SECOND FLOOR PLAN
SCALE: 1/4"=1'-0"
8'-0" C.L.S. HGT.
SET WINDOWS AT 6'-8" A.F.F.

TRIANGLE DEALS, LLC
"THE DRAIME"

PLAN NO.
DK2618

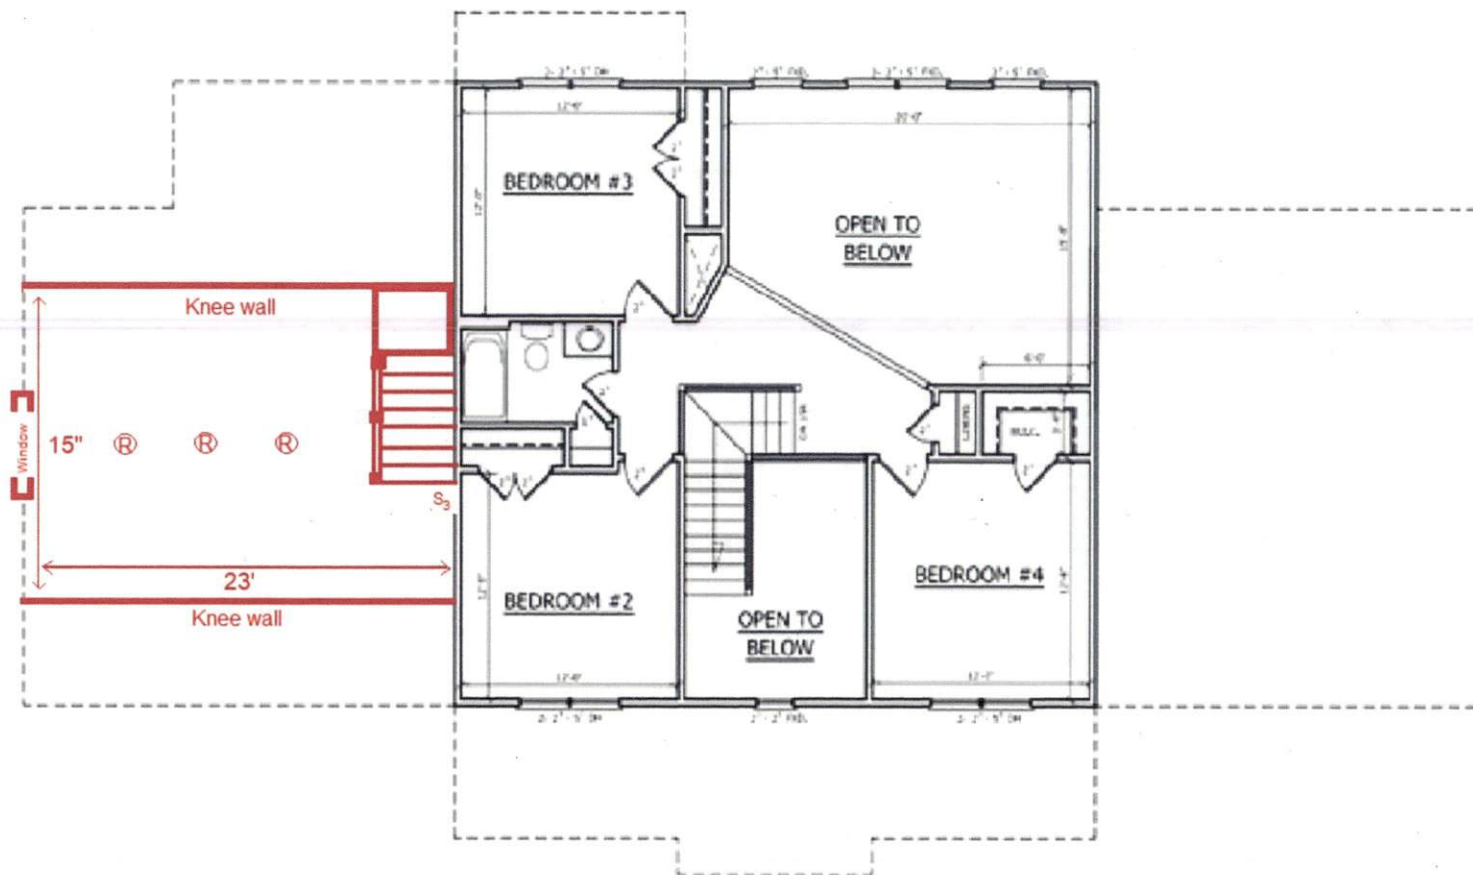
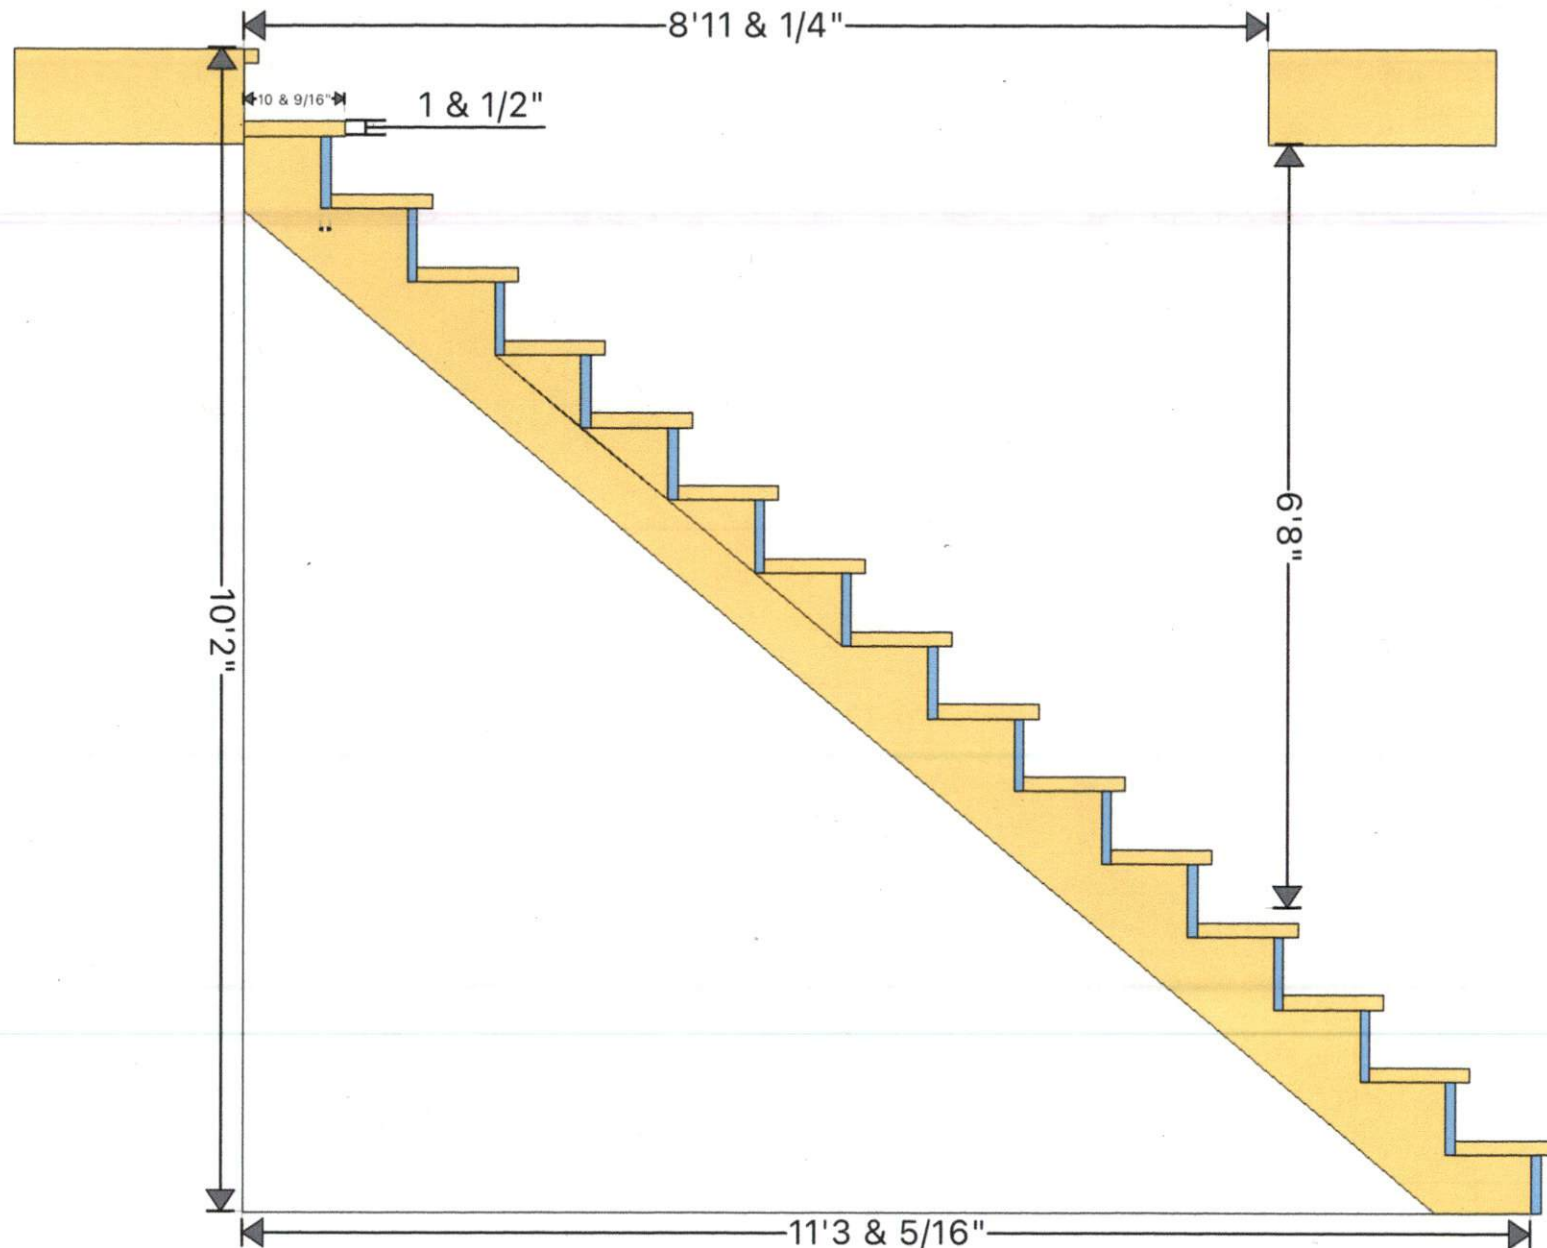
Install code complaint footings in existing slab to support header. Cut joists shall be attached to header with proper I joist hangers. Footing for beam support must be inspected prior to pour. Top of stairs shall have 3x3 landing. All of staircase including landing shall have not less than 6'8" clear headroom. Stair case shall be fire separated from garage. Must have interconnected smoke detector in play room. Must have code compliant egress window in playroom.

TJI Floor joist
3'8"
cut 2 TJI and
header off
for ac
